**Re: Third Submission Review – Aurora One Phase I – Infrastructure Site Plan (ISP)**  
Application Number: **DA-2241-01**  
Case Number: **2022-6006-00**

## Third Submission Review

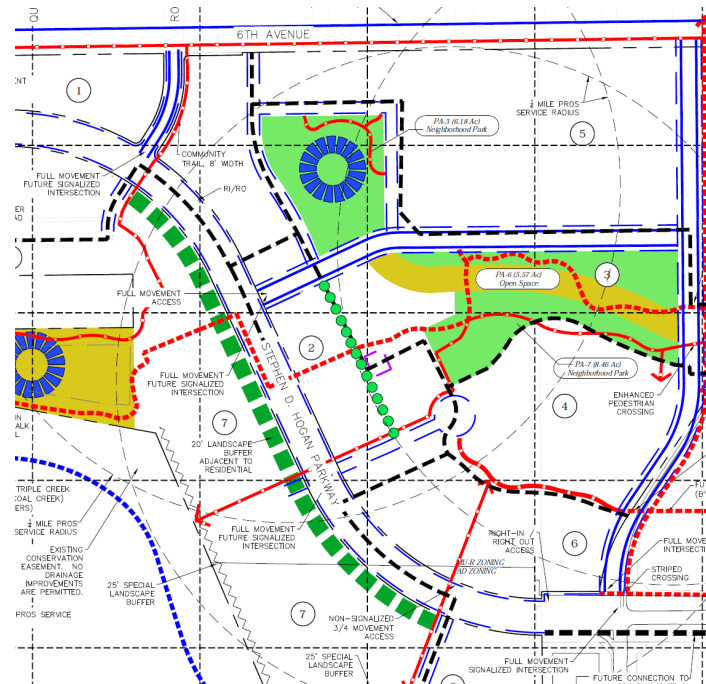
- 2E. Provide a detail of the special paving for reference.
- 2F. Repeat comment: Continue to work with staff to clarify the timing of planned bike and pedestrian crossings planned for Stephen D. Hogan Parkway. Thank you for showing the crosswalk alignments and locations. However, it is generally preferred that these are installed along with signalization of the intersection. Please add notes and details to clarify the design and timing. Address the regional multi-use trail crossing of Stephen

D. Hogan Parkway that is shown on the master plan between the proposed collector streets. Will this alignment be shifting with the pond location? Show/address how the regional connectivity and alignment planned in the master plan will be carried out with this and adjacent ISP's. (Snip of the master plan for reference below)
